marantz® SERVICE BULLETIN		Date: 30-June-2003	Model: SR4300,SR4400
		Page: 1 / 1	REF.NBR: MZ03-023
Circulation:		Subject:	
Application:		The sound is interrupted, when the playback DIGITAL of CD-R/RW of the SCMS signal.	
x for information customer complaint in case of service mandatory	See Below	Int.ref:

marantz® SERVICE BULLETIN		Date: 31-Oct.-2003	Model: SR4300/SR4400
		Page: 1 / 3	REF.NBR: MZ03-047
Circulation:		Subject:	
Application:		The problem of the Speaker protection circuit.	
x for information customer complaint in case of service mandatory			
Service code XE00 XE00xxxxxxxxxx

marantz® SERVICE BULLETIN		Date: 30-June-2003	Model: SR4300,SR4400
		Page: 1 / 1	REF.NBR: MZ03-025
Circulation:		Application:	
x for information customer complaint in case of service mandatory		See Below	
		Subject: FM(with RDS) signal is received, Frequency Indication becomes the setup of default by the remote control operation . (only N and A version occurs)	
		Int.ref:

SR4300

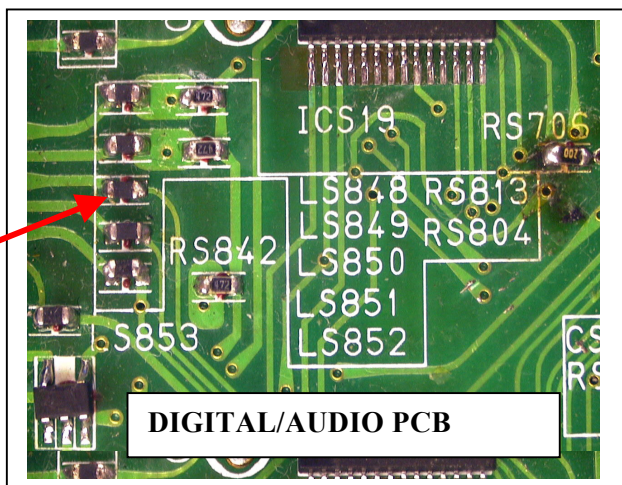
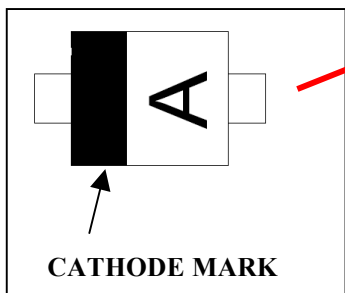
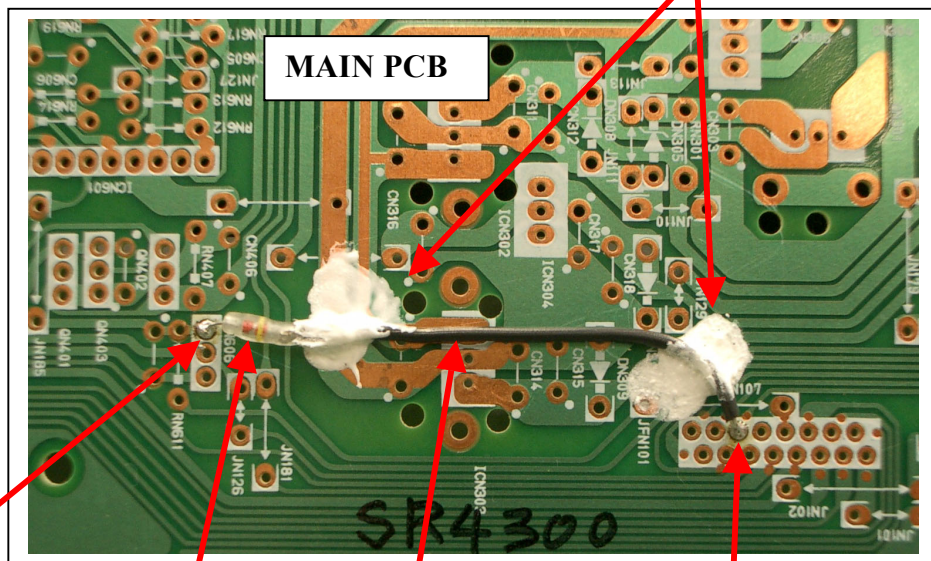
LS850 is changed to
Part no. *HD201810R

Caution
JFS08 (FPC CONNECTOR) side is
CATHODE

BASE of QN606

DN601
Part no. HD20002000

No.5 pin of JFN101

Insulation tube is used

- 1) Chip Resistor **LS850** (100 ohm 1/16W part no. NN05101610) is changed to **Silicon Diode (Part no. *HD201810R--- 1SS400 POHM: EMD2, EIAJ: SC-79, JEDEC: SOD-523)**.

- 2) Chip Resistor **DN601(Part no.HD20002000---Silicon Diode 1SS254 ROHM)** is added between BASE of QN606 SEMICOM.COMP and No.5 pin of JFN101 Connector

SR4400

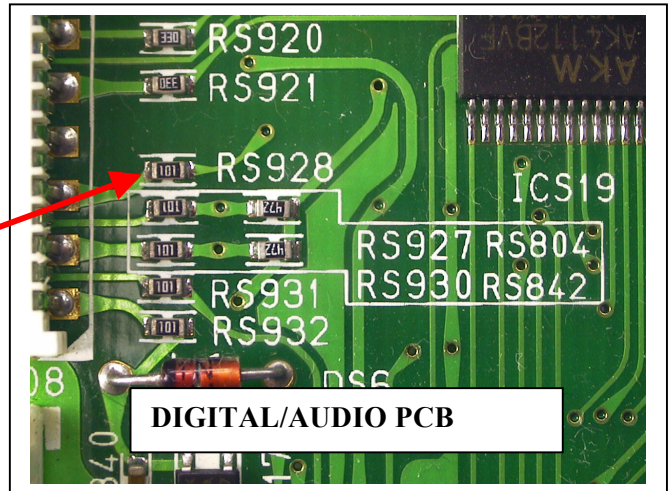
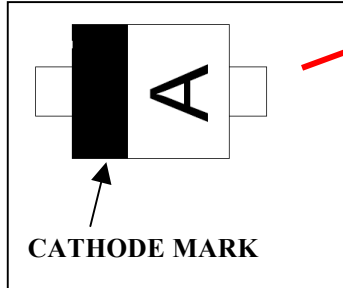
RS928 is changed to
Part no. *HD201810R

Caution
JFS08 (FPC CONNECTOR) side is
CATHODE

BASE of QN606

No.5 pin of JFN101

Insulation tube is used

DN601
Part no. HD20002000

- 1) Chip Resistor **RS928** (100 ohm 1/16W part no. NN05101610) is changed to **Silicon Diode (Part no. *HD201810R--- 1SS400 POHM: EMD2, EIAJ: SC-79, JEDEC: SOD-523)**.

- 2) Chip Resistor **DN601(Part no.HD20002000---Silicon Diode 1SS254 ROHM)** is added between BASE of QN606 SEMICOM.COMP and No.5 pin of JFN101 Connector
